In Situ Testing of Shallow Depth Helical Heat Exchangers for Ground Source Heat Pump Systems (OR-16-C044)

Detected error Dic-10-2015 would imply the following changes:

Figure 6 (Original)

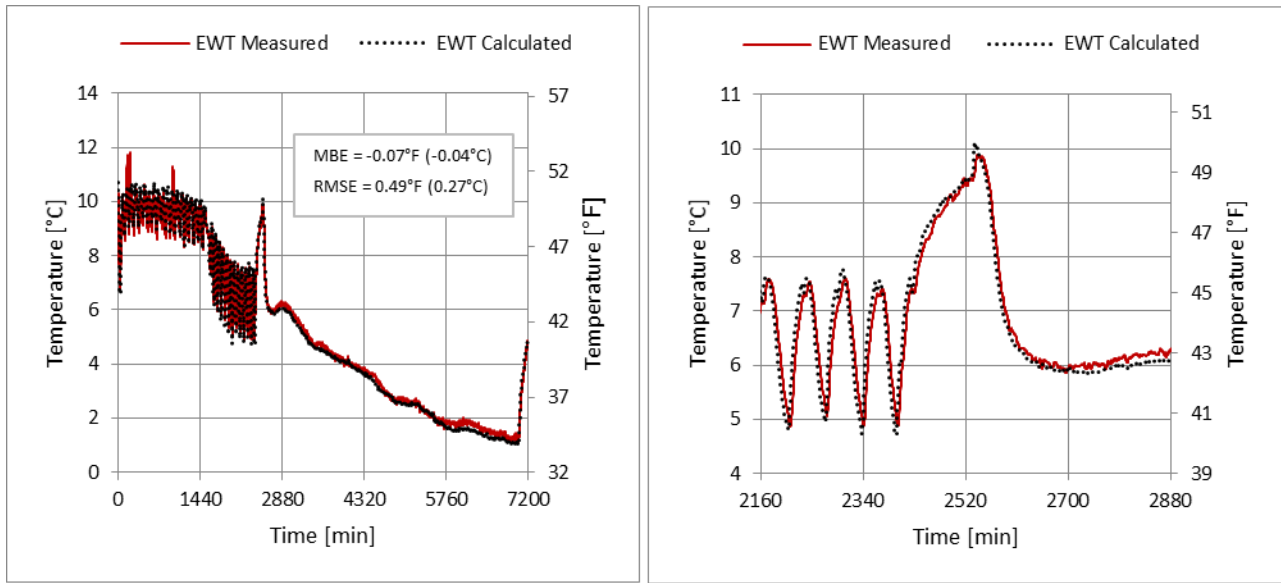
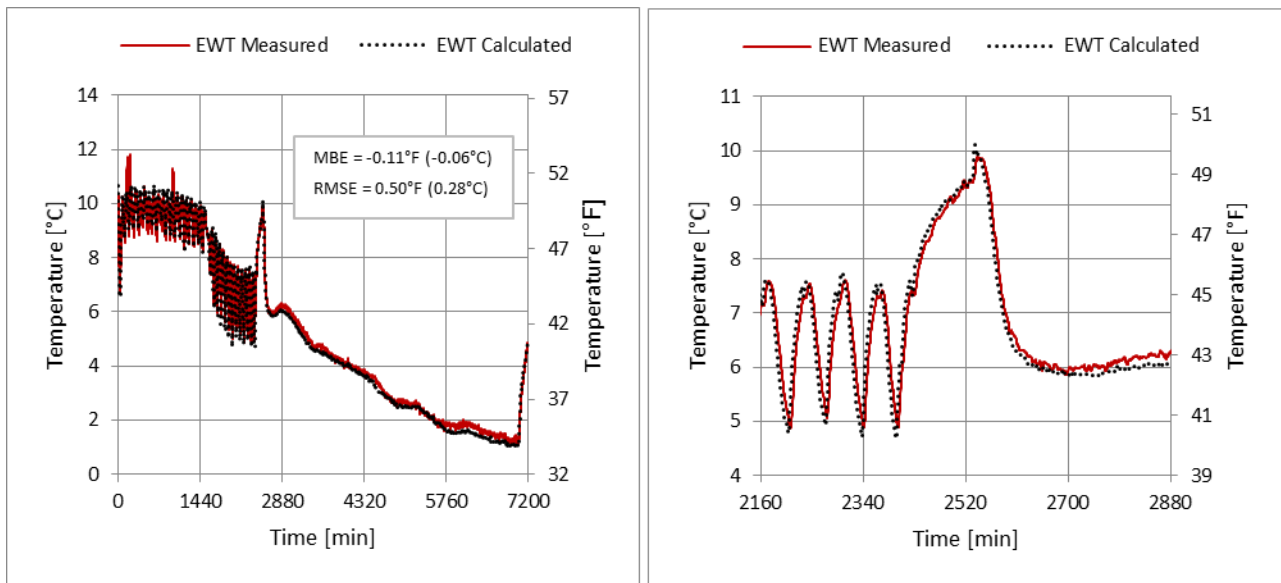
Heating Test

Figure 6 (Corrected)

Figure 7 (Original)

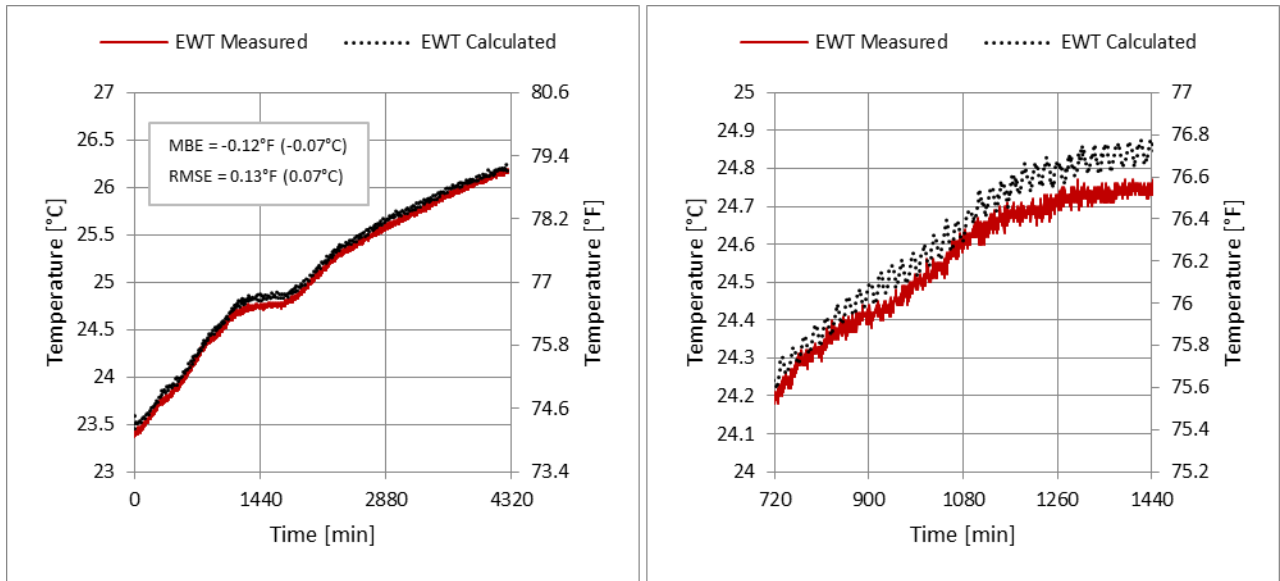
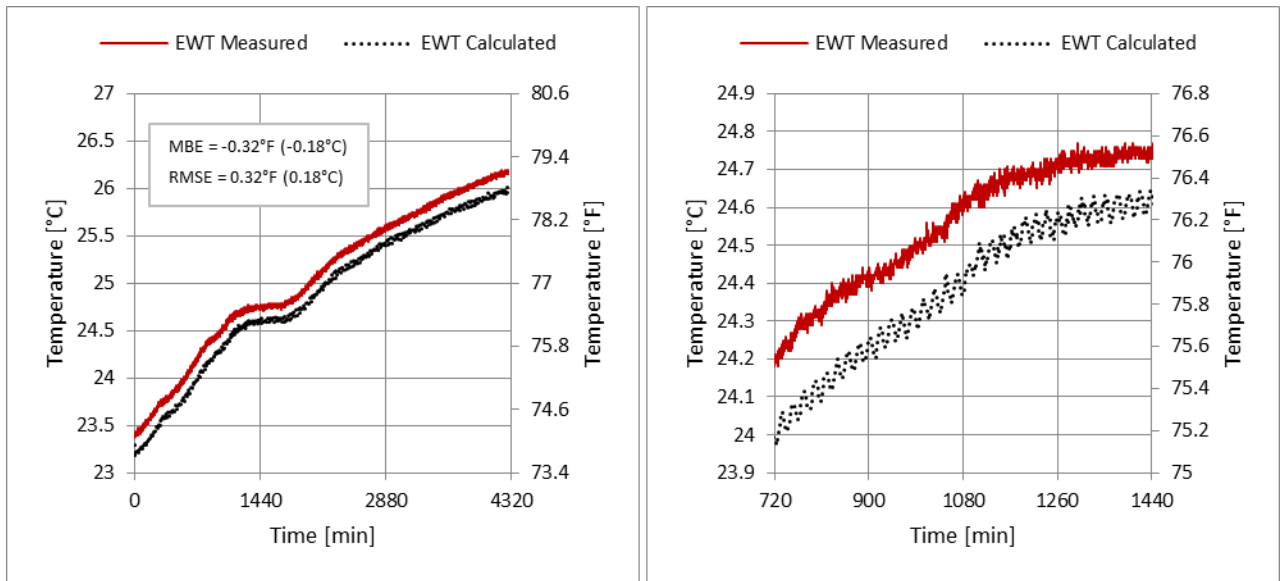
Cooling Test

Figure 7 (Corrected)
